**PUBLIC UTILITY COMMISSION OF OREGON
STAFF REPORT
SPECIAL PUBLIC MEETING DATE: April 20, 2021**

SUBJECT: PORTLAND GENERAL ELECTRIC:
(Docket No. LC 73)
Acknowledgement of the 2019 Integrated Resource Plan Update.

Figure 1: Mixed full clean action plan window resource additions

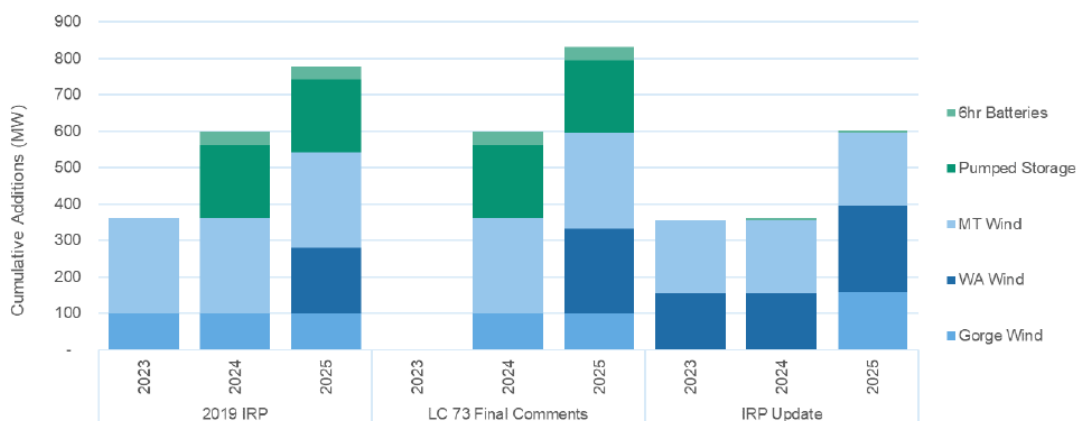
PGE's 2019 IRP Update decreases the amount of dispatchable capacity the Company plans to acquire in the action plan timeframe, as shown in Figure 1, which is reproduced from IRP Update page 52:

PGE's IRP Update suggests that the Douglas PPA caused the change shown in Figure 1. However, PGE's June 2020 supplemental testimony in Docket No UE 377, the 2021

power cost update docket, describes the Douglas PPA as providing approximately 100-160 MW of capacity.¹³ This confirms to Staff that the Douglas PPA does not provide enough capacity on its own to replace all of the 595 MW of dispatchable capacity selected through 2025 from PGE’s 2019 IRP preferred portfolio, which is reproduced from IRP page 215 below:

Staff finds that PGE's IRP Update moves away from the dispatchable capacity resources in the 2019 IRP Preferred Portfolio and instead acquires slightly more non-dispatchable renewable resources through 2025, followed by 500 MW of additional non-dispatchable renewables in 2026. The 2026 addition is attributable to the most recent PTC extension, and may also be influenced by the forecast of continually increasing market prices throughout the planning timeframe. A high market price forecast tends to support the economics of procuring resources and going long to the market as a net energy seller.

In order to identify the extent to which the IRP model selection of near-term renewables is dependent on assumptions about increasing market prices and imminent PTC expiration, PGE should work with Staff to develop sensitivities for analysis in the RFP. PGE should use these sensitivities to inform its final shortlist and its choice between dispatchable, non-emitting capacity and near-term renewable resources for meeting its capacity needs. Staff requests that PGE collaborate with Staff in developing low market price and PTC extension sensitivities and reporting for inclusion with the Final Shortlist in the upcoming RFP.¹⁴

Figure 2: PTC extension effect on cumulative renewable additions in the preferred portfolio reference case

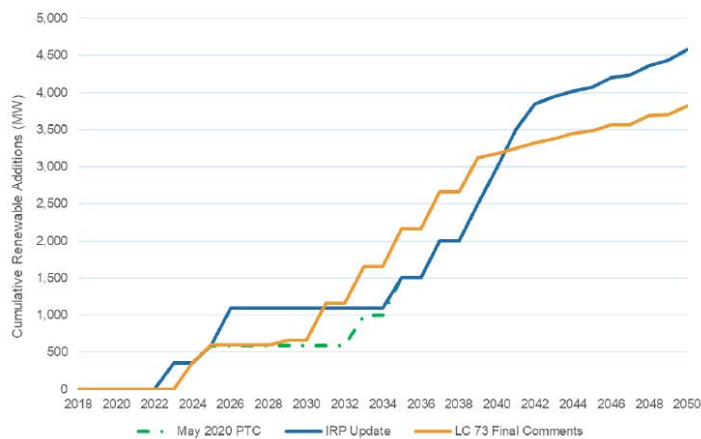
The 2019 IRP Update preferred portfolio has less near-term dispatchable capacity than the 2019 IRP preferred portfolio, and includes additional renewables in 2023 and 2026. This appears to be a result of the 2020 PTC extension, as shown in the figure below reproduced from IRP Update page 53, which shows additional renewable additions before the extended 2026 PTC expiration:
